Concord Planning Board  
141 Keyes Rd., 1<sup>st</sup> Fl  
Concord, MA 01742

The West Concord Advisory Committee (WCAC) has reviewed the development plans prepared by Spruhan Engineering P.C. for 166 Commonwealth Ave, submitted by Thomas Falwell of Comins & Newbury LLP. The developers have joined two of our recent WCAC monthly meetings to present the plans to us and we have been able to give feedback and ask them questions.

Figure 1. Drone view of the location of 166 Commonwealth Ave. with respect to other buildings, roadways, and parking entrances

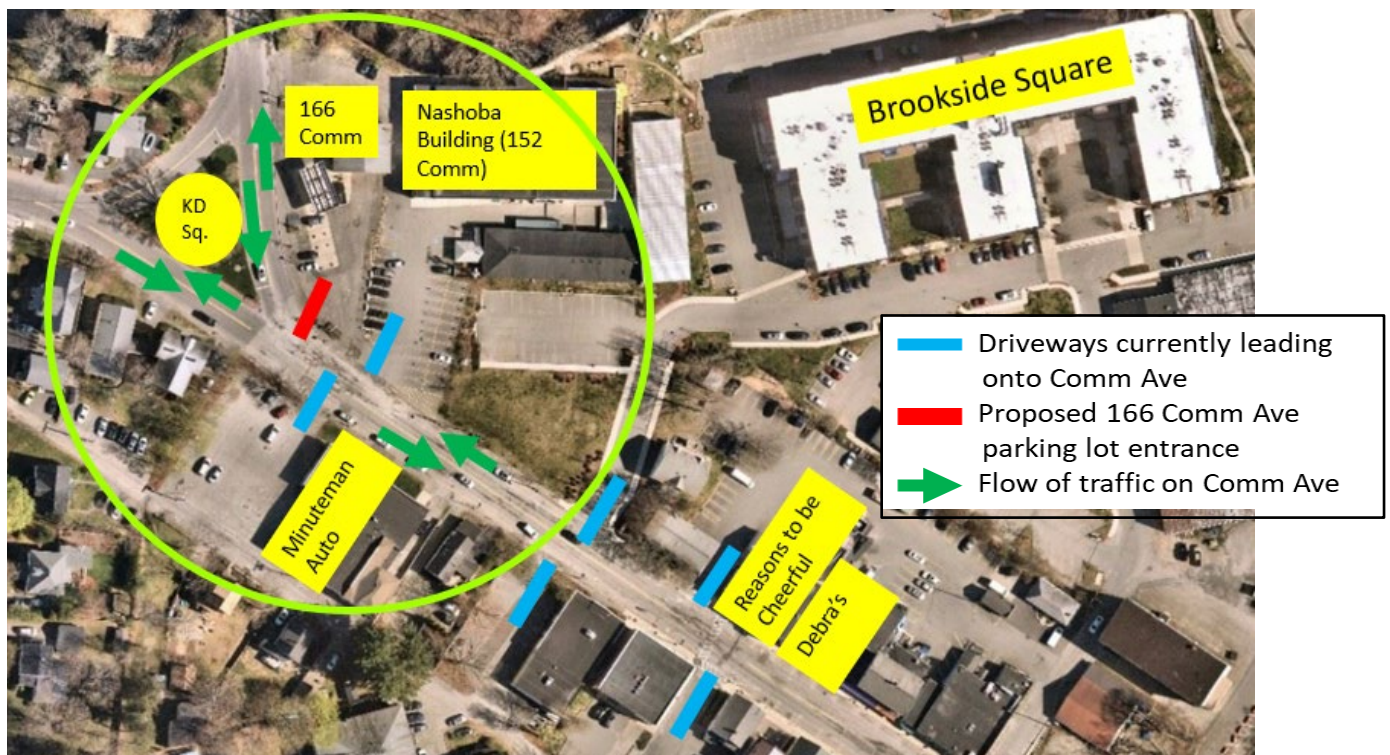
2. The proposed entrance to the parking area for the building is next to the separate entrance to the 152 Commonwealth Ave parking lot and across from the Minuteman Automotive entrance. It creates a perilous 5-way intersection in a location that doesn't have stop signs or a traffic light. It would be highly advisable to have one driveway that serves both 152 Comm Ave. and 166 Comm Ave. rather than two separate driveways for buildings that are right next to each other. The developer told us that they haven't been successful in coordinating with the owners of 152 Comm Ave. on driveway sharing. See Figure 1 or [Google Maps Street View of this location](#).

Figure 3. Reported motor vehicle accidents with over \$1000 in damage in the vicinity of West Concord Junction, Jan. – July 2023.

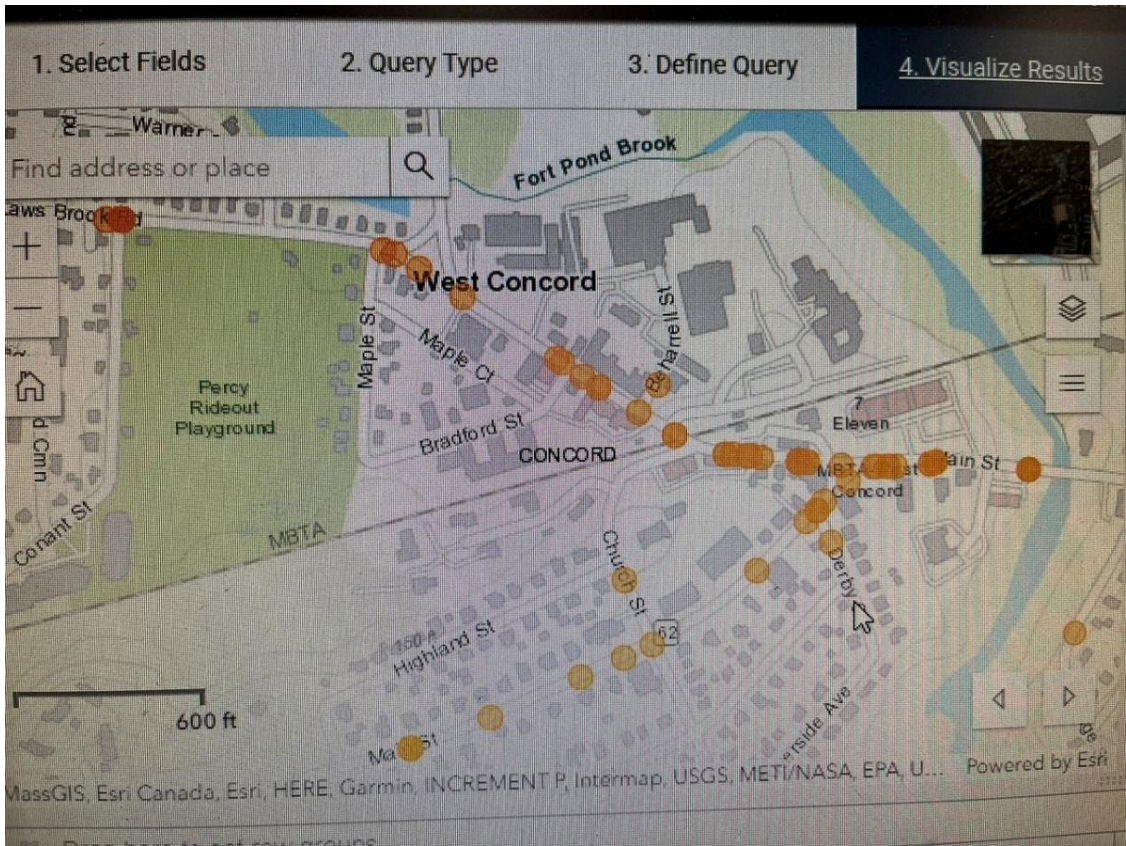
13. On the next page, Figure 3 shows a map of reported motor vehicle accidents that had over \$1,000 of damage from Jan. – July 2023, provided by Town of Concord Public Safety Officer, Ron Holsinger. It shows how dangerous the half mile of road from Main Street down Commonwealth Ave to Kenneth Dunn Square is. We are concerned that adding a high-volume driveway on the edge of Kenneth Dunn Square, which expands the intersection to serve 5 directions of traffic, will exacerbate an already safety-challenged location in the Junction.
